Product Advisory

Issue Date: Aug 26, 2021

Supply chain continuity: Adding Foxconn Nanning in China as a contract manufacturing site for Ethernet NIC to maintain supply chain continuity.

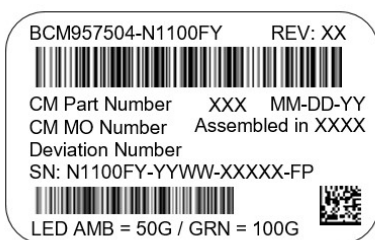
The CM location is traceable through the board serial number. The letters “FN” at the suffix of the serial number indicate Foxconn, Nanning in China manufactured the board. Below is an illustrative example. OEMs may have a different CM site code.
